Our Ref: P00031_L3_ Response to Transport for NSW.docx
3 March 2021

Ref: CR2020/005288&SF2020/208998

SUBJECT: RESPONSE TO SUBMISSION
PROJECT: MOD TO TINONEE PA (MP 05_0038 MOD 1)

CARTERS CREEK ROAD LONGITUDINAL SECTION
SCALE 1:500 HORIZONTAL, 1:100 VERTICAL

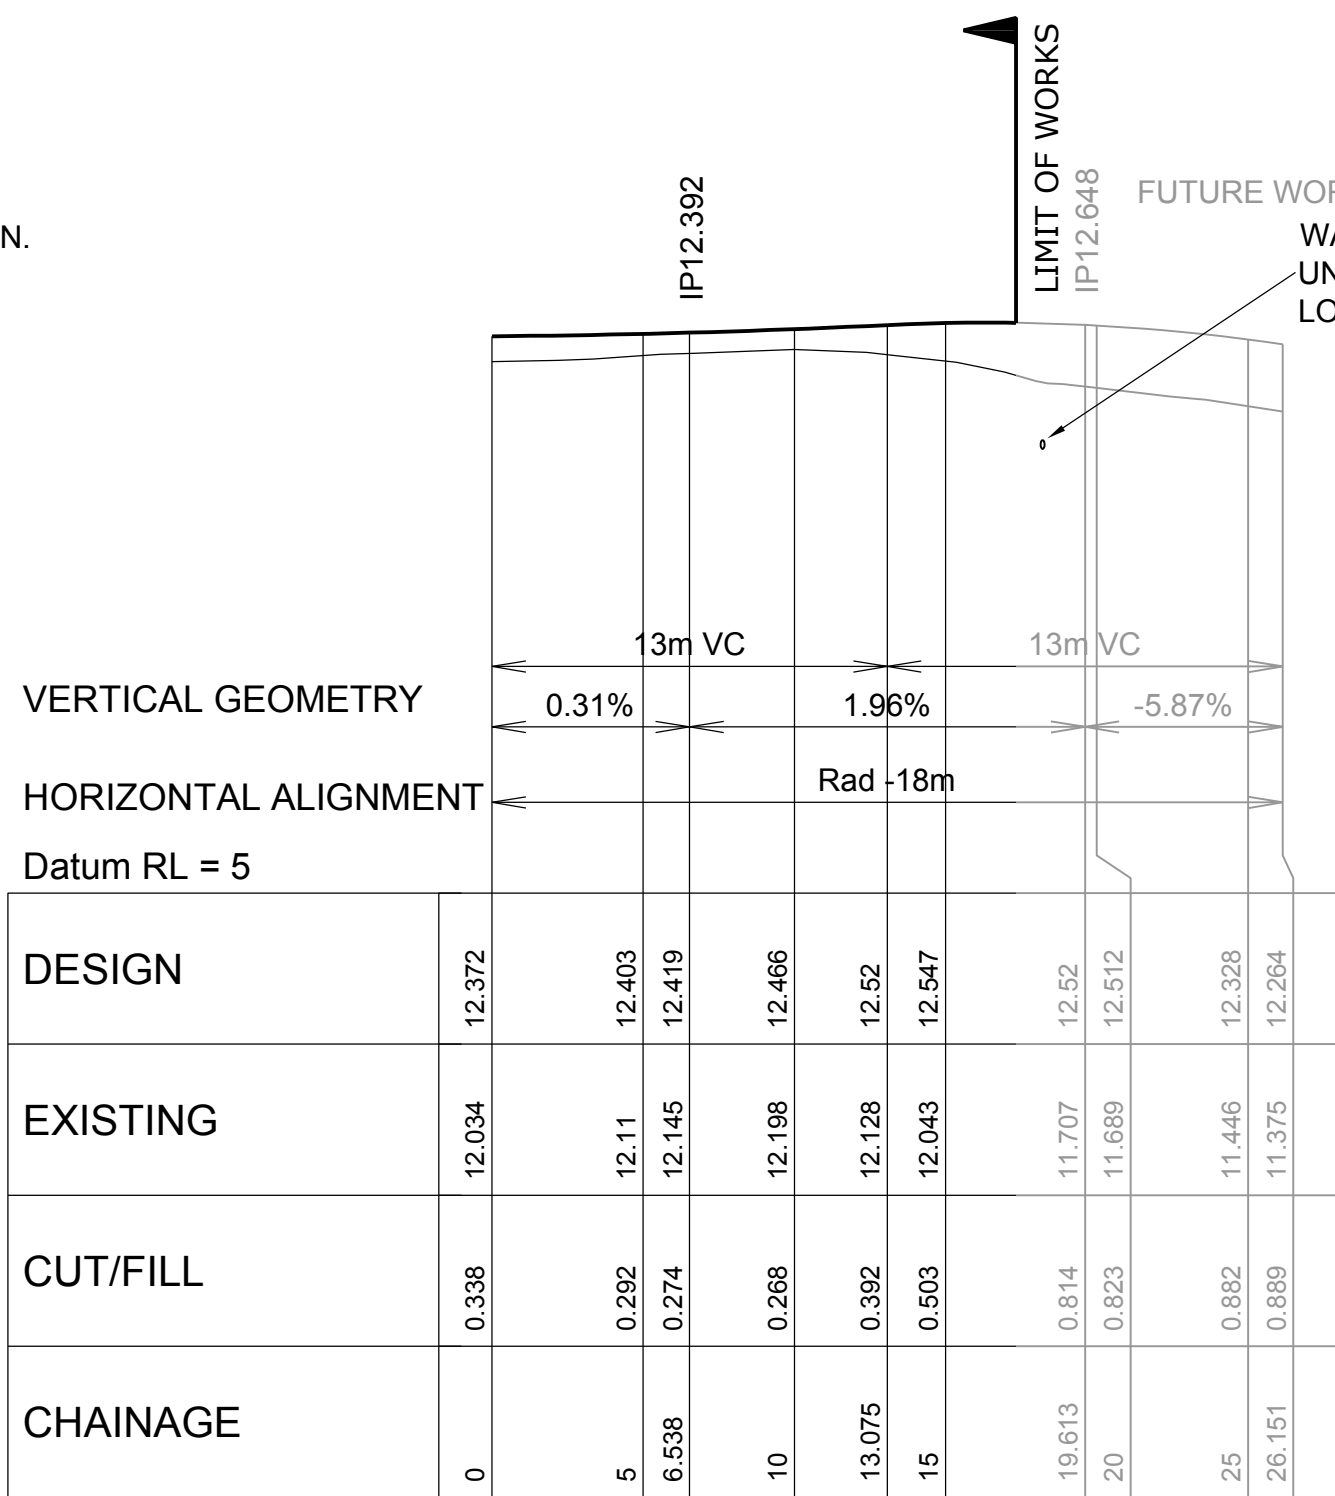
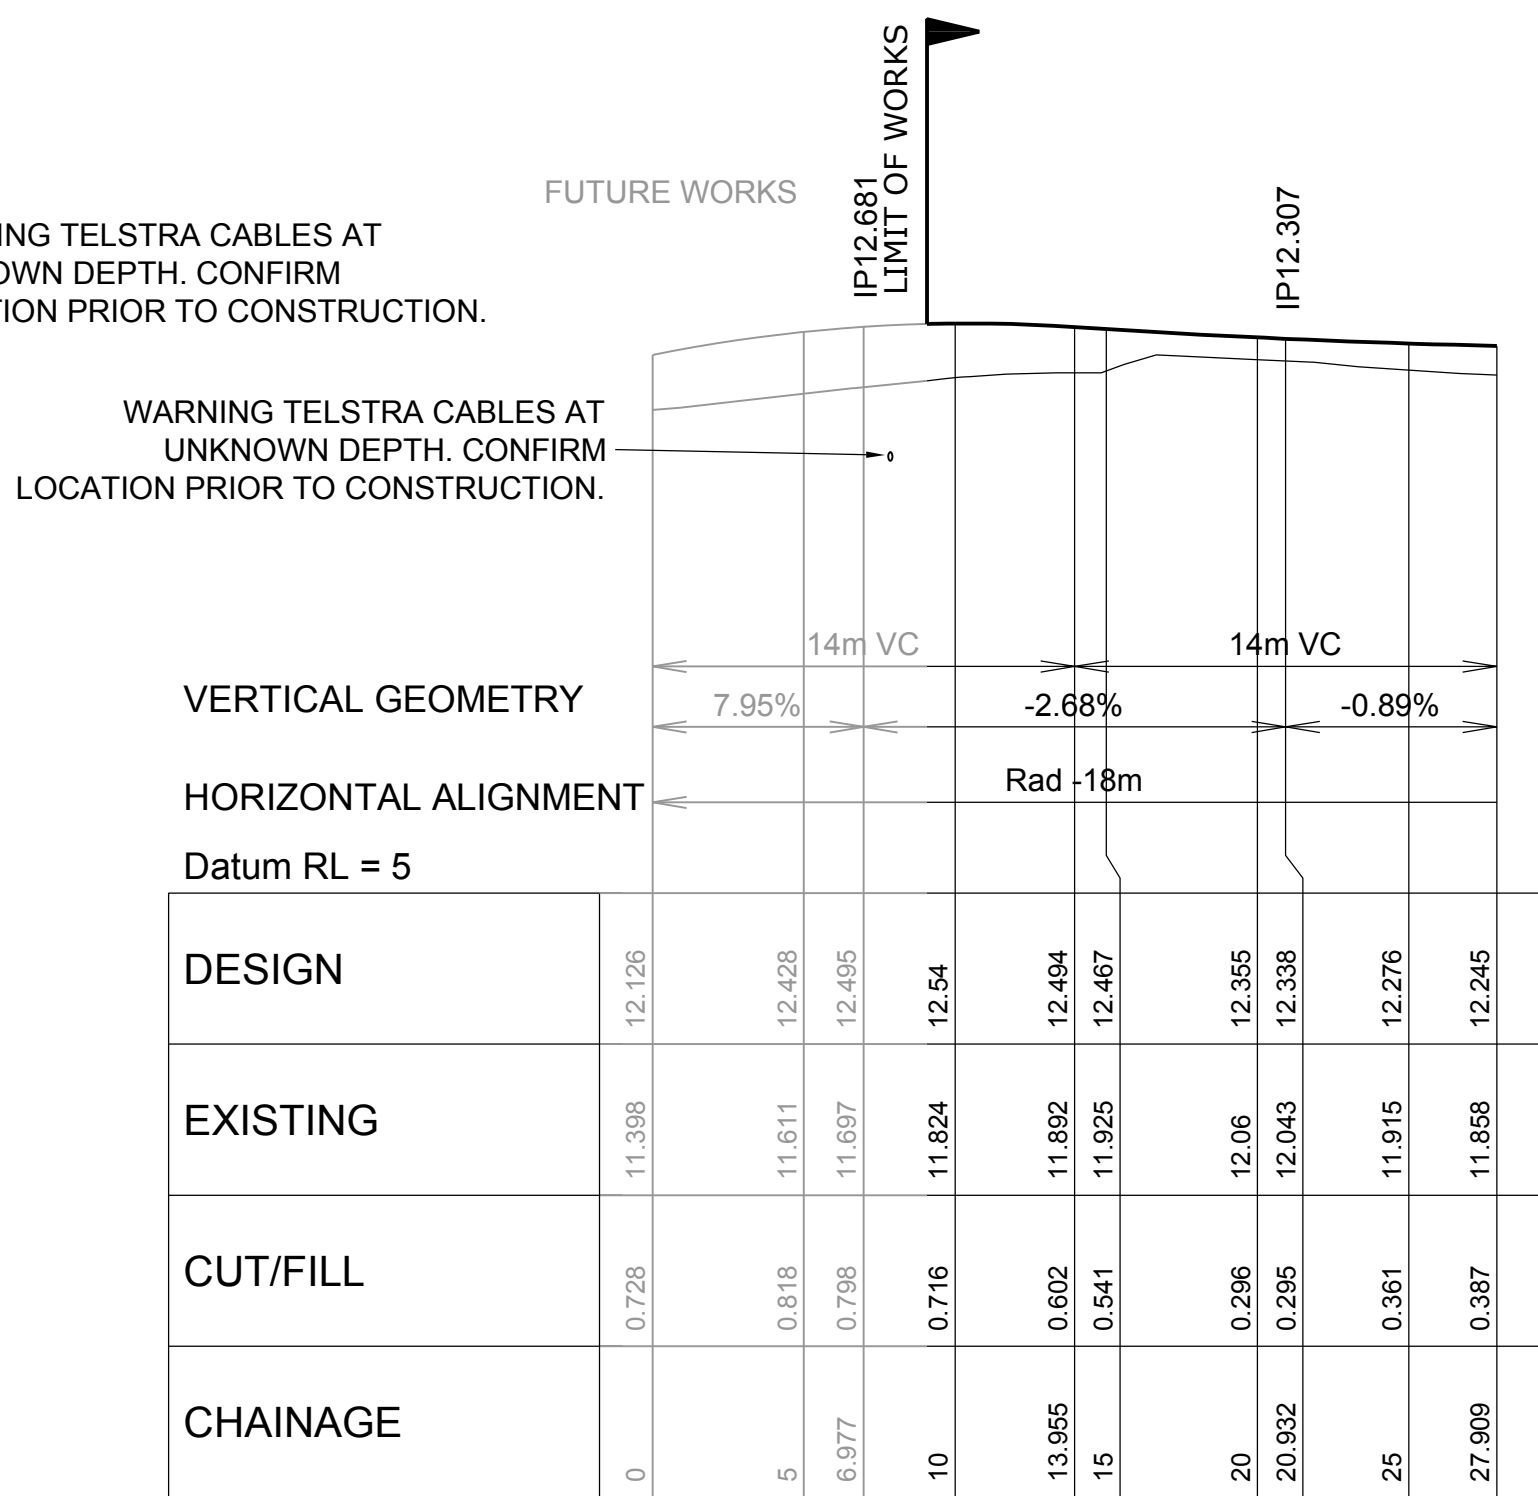
- Adequacy of the proposed intersection treatments with the main subdivision entry and Urray Road.

The main subdivision entry treatment was constructed in October 2015 to a CHR/BAL treatment standard as required by Condition E35 of the Project Approval. Copies of the approved plans for construction are attached.

PROPOSED SUBDIVISION STAGE 2 ILLIDGE ESTATE

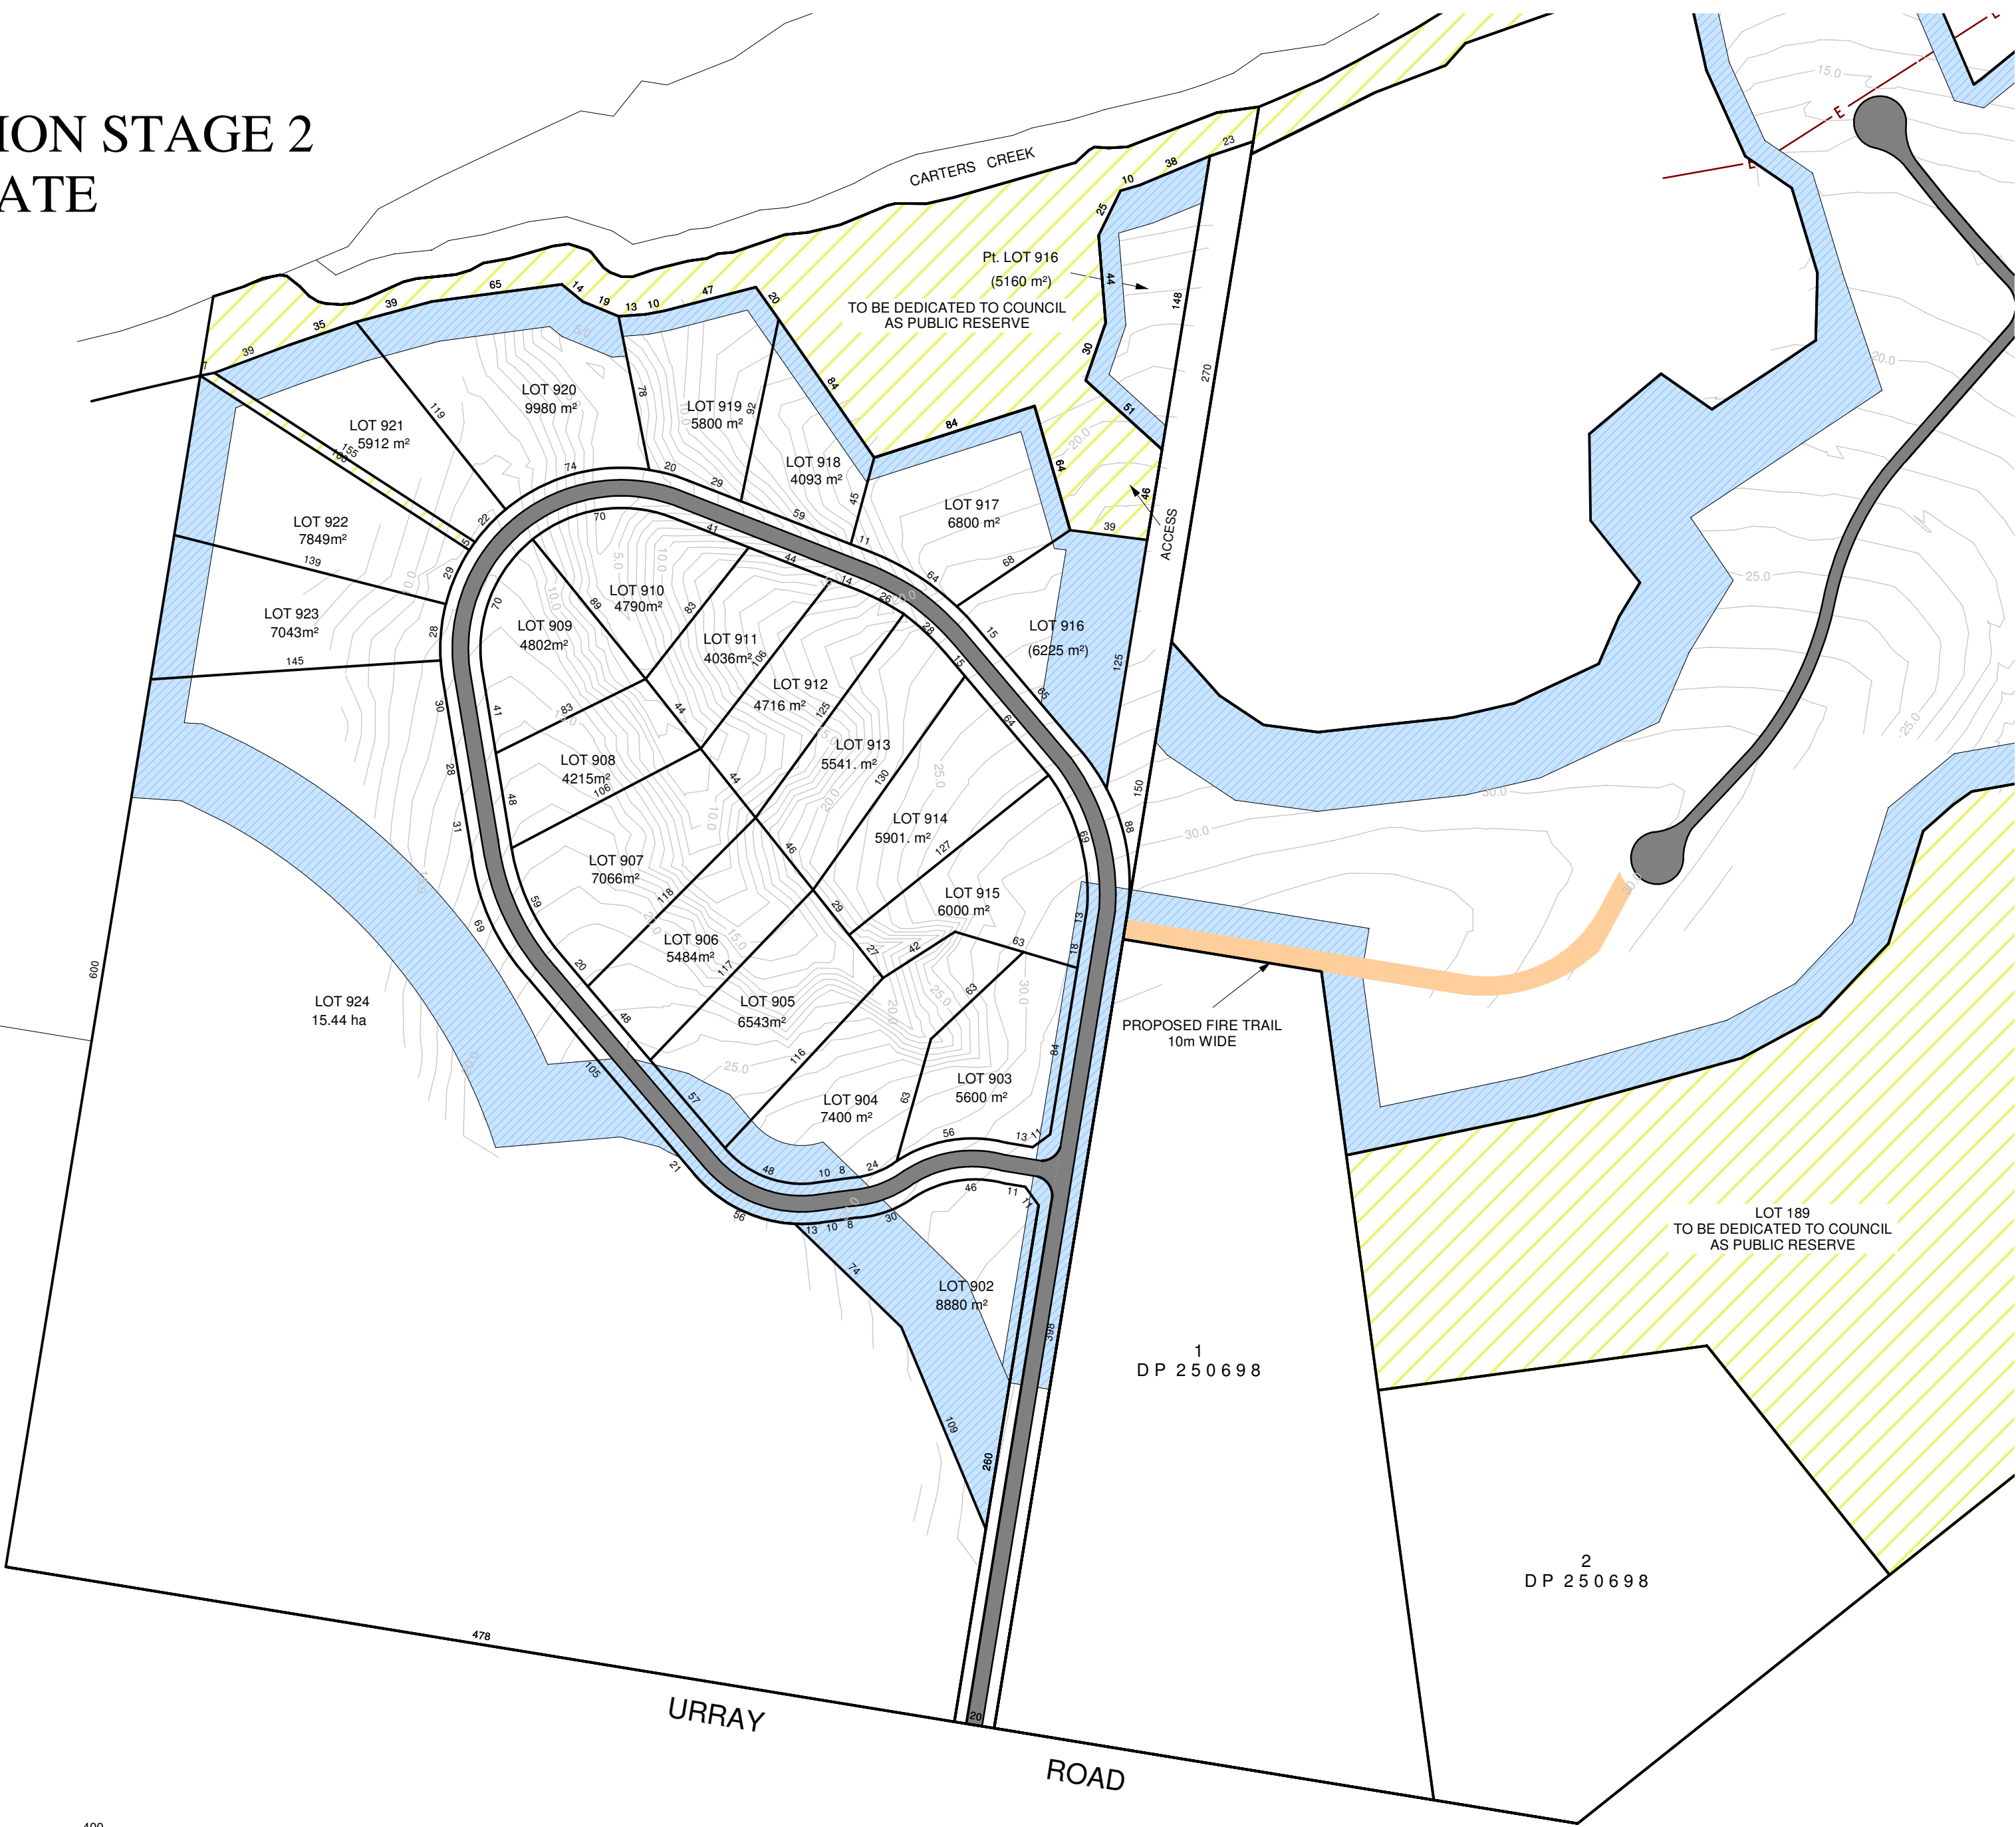
- Inclusion of additional Lot 924
- Potential impacts on the endangered flora species *Diuris flavescens*
- Foreshore access in Stage 2
- Northern part of Lot 917
- Foreshore access in Stage 3 and access to Crown Lot 7008 DP 96763
- Extent of clearing in Stage 2 as shown on plans
- Supplementary Assessment of Significance
- Plans of Management

Lot 924 has been deleted from the proposed subdivision. Stage 2 now reflects the same subdivision layout as originally approved (with required design changes incorporated as discussed further below). A copy of this revised plan is attached.

Condition B1 of the original project approval required adjustment to the lot boundaries in the then Stage 5 (now Stage 2) in order to protect the endangered flora species *Diuris flavescens* (see attached). The layout of Stage 2 as proposed in this modification incorporates those changes and remains unchanged in lot numbers and configuration. It is therefore submitted that the proposed Stage 2 is in compliance with the current approval and could therefore be constructed in accordance with that approval. The proposed modification of this section of the site now relates only to the numbering of that stage.
